CHANGE ORDER

CHANGE ORDER NUMBER
2
11/15/2021
Page 1 of 16

SORDERED BY ENGINEER UNDER SECTION 1-04.4 OF THE STANDARD SPECIFICATIONS. □ CHANGE PROPOSED BY CONTRACTOR.	PROJECT IDENTIFICATION PROJECT NAME: North Creek Trail Phase 1 – SR524 to Sprague Drive PROJECT NUMBER: RC1776, RR6318, RR6323, RR6319		
CONTRACTOR ENDORSEMENT: SIGNATURE DATE	CONTRACTOR: Rodarte Construction, Inc. ADDRESS: 17 East Valley Hwy E Auburn, WA. 98092		
PRINT NAME TITLE

This change order compensates the Contractor for added work required to relocate and reconnect Alderwood Water and Wastewater District hydrants and services that were not shown or incorrectly quantified in the Contract Plans and Proposal.

PLAN AND PROFILE STA 42+00 TO STA 46+00

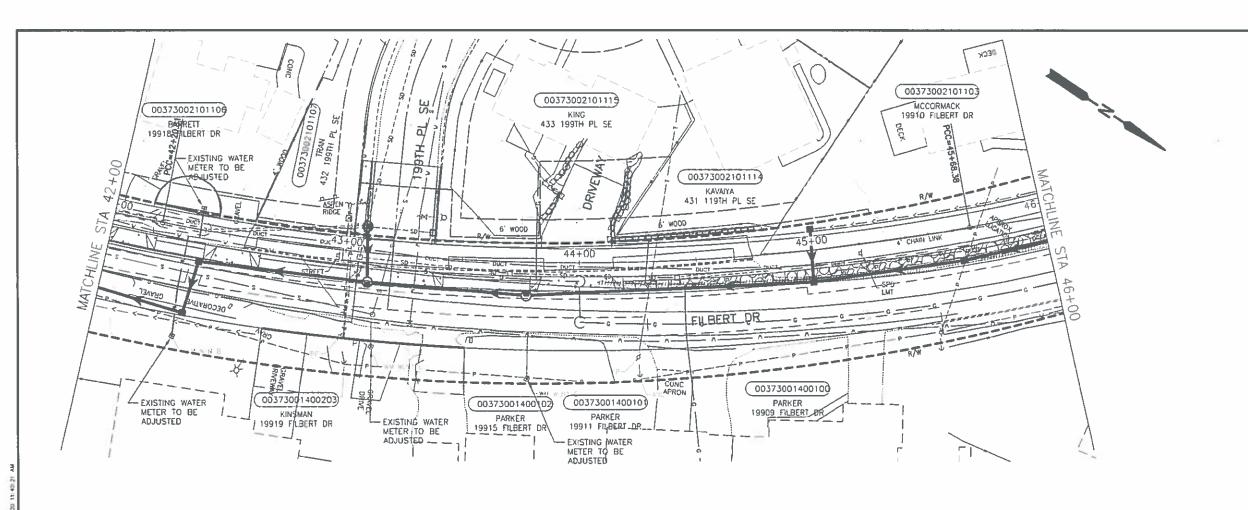
- 1 REPLACE EXISTING WATER SERVICE AND METER BOX WITH
 1" SERVICE PER AWWD STD DWG WD-2, WD-4 AND
 WD-4A, REPLACE PRV PER AWWD STD DWG WD-4C,
 COORDINATE WITH AWWD TO TRANSFER EXISTING METER
 AND REMOTE READ EQUIPMENT, NEW METER/PRV BOX
 LOCATION SHOWN IS APPROX. RECONNECT PRIVATE
 SERVICE.
- 2 INSTALL FIRE HYDRANT ASSEMBLY PER AWWD STD DWG WD-7.
- (3) INSTALL CASING PER AWWD STD DWG T1-1, SIZE AS INDICATED. CASING SHALL BE CENTERED ON PROPOSED CULVERT AND BEDDED PER DETAIL ON SHEET AW11.
- REMOVE EXISTING VALVE BOX AND ABANDON VALVE IN PLACE UNLESS OTHERWISE NOTED BY THE DISTRICT INSPECTOR. EFFECTED ROADWAY SHALL BE RESTORED PER SNOHOMISH COUNTY EDDS SECTION 8-05.C.2 RESTORATION REQUIREMENTS FOR POTHOLES.
- 5 INSTALL THRUST BLOCKING PER AWWD STD DWG WD-11.

PLAN AND PROFILE STA 46+00 TO STA 50+00

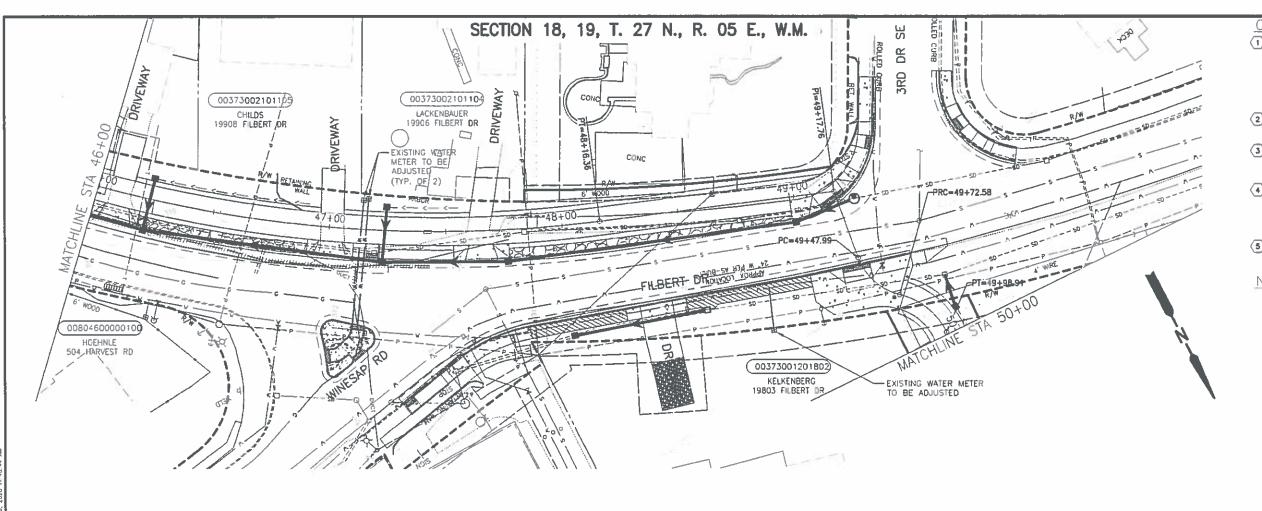
- 1) REPLACE EXISTING WATER SERVICE AND METER BOX WITH 1" SERVICE PER AWWD STD DWG WD-2, WD-4 AND WD-4A. REPLACE PRV PER AWWD STD DWG WD-4C. COORDINATE WITH AWWD TO TRANSFER EXISTING METER AND REMOTE READ EQUIPMENT. NEW METER/PRV BOX LOCATION SHOWN IS APPROX. RECONNECT PRIVATE
- 2 INSTALL FIRE HYDRANT ASSEMBLY PER AWNO STD DWG WD-7.
- (3) INSTALL CASING PER AWWD STD DWG T1-1, SIZE AS INDICATED. CASING SHALL BE CENTERED ON PROPOSED CULVERT AND BEDDED PER DETAIL ON SHEET AW11.
- (4) REMOVE EXISTING VALVE BOX AND ABANDON VALVE IN PLACE UNLESS OTHERWISE NOTED BY THE DISTRICT INSPECTOR. EFFECTED ROADWAY SHALL BE RESTORED PER SNOHOMISH COUNTY EDDS SECTION 8-05.C.2 RESTORATION REQUIREMENTS FOR POTHOLES.
- 5) INSTALL THRUST BLOCKING PER AWWD STD DWG WD-11.
